| Subject: SEAT BELT SLOW TO RETRACT | Bulletin No: 08-001/11 |

2006 Miata

2007-2011 MX-5

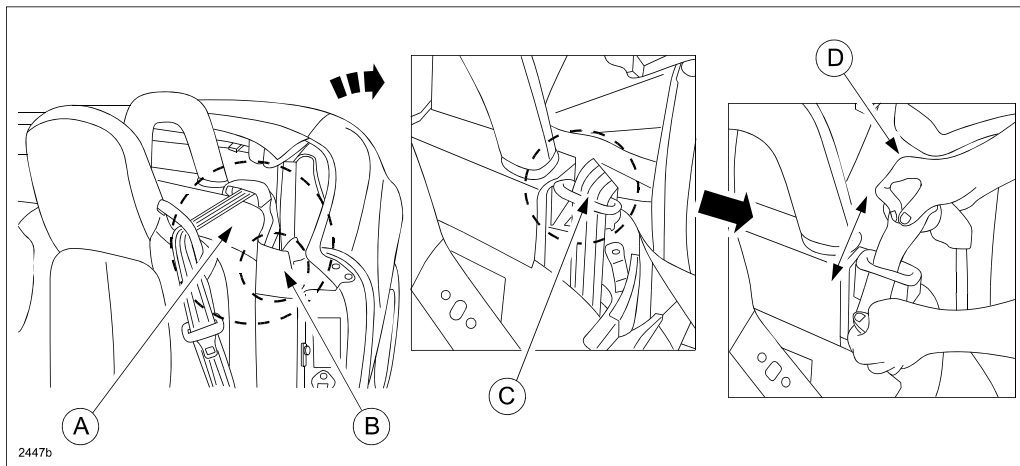
- c. Remove fastener (B) and anchor cover (A) to remove any dirt, dust or smudges on the seat belt anchor area D-ring (C).

- d. Clean the anchor area using a neutral detergent on a rag (D) as shown above.

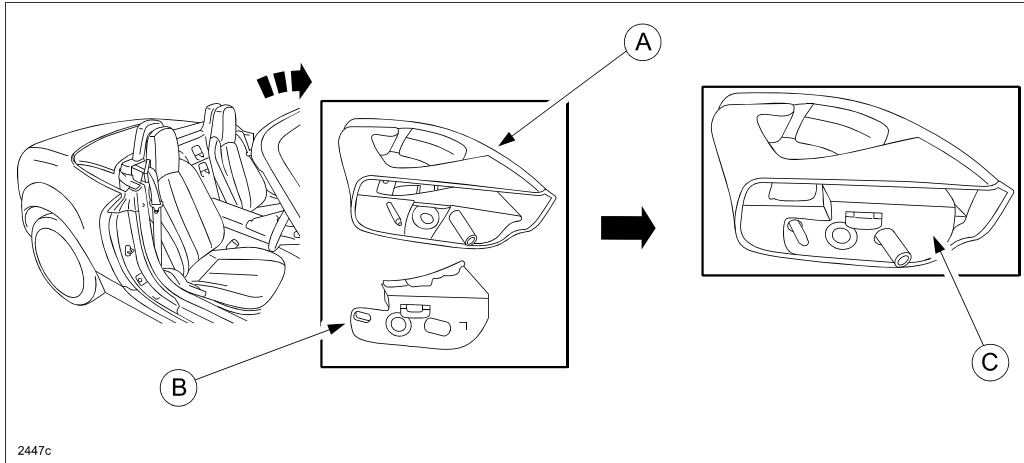
6. Replace the left and right seat belt guides (A) and protectors (B) with new parts according to Steps a - d below.
 - a. Loosen the seat belt guide and protector attachment screw.
 - b. Remove the seat belt guide (seat belt guide and protector are combined).

- c. Install the new protector inside of the new belt guide (C) as shown above.
 - d. Install the seat belt guide and protector using the original screw.

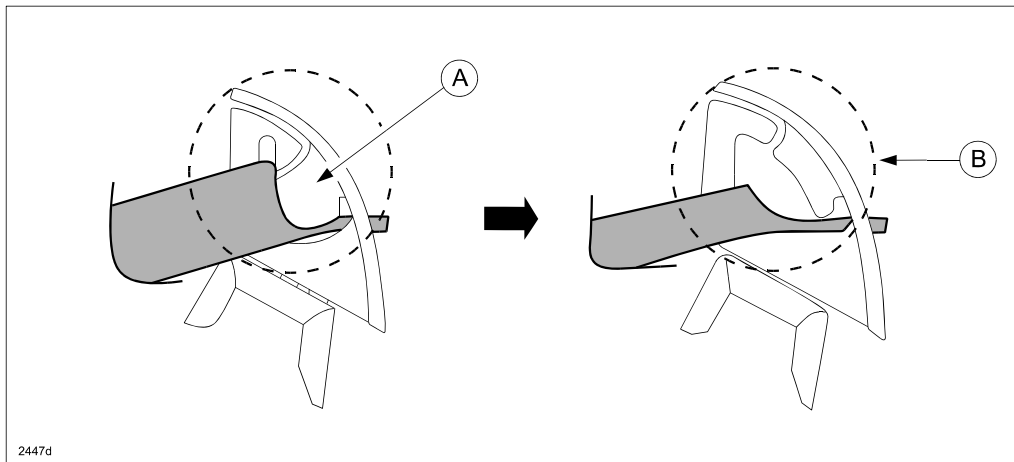
The shape of the belt guide has been changed and the friction resistance within the seat belt has been reduced.

NOTE: The shape of the belt guide has been modified from the old design (A) to the new design (B).
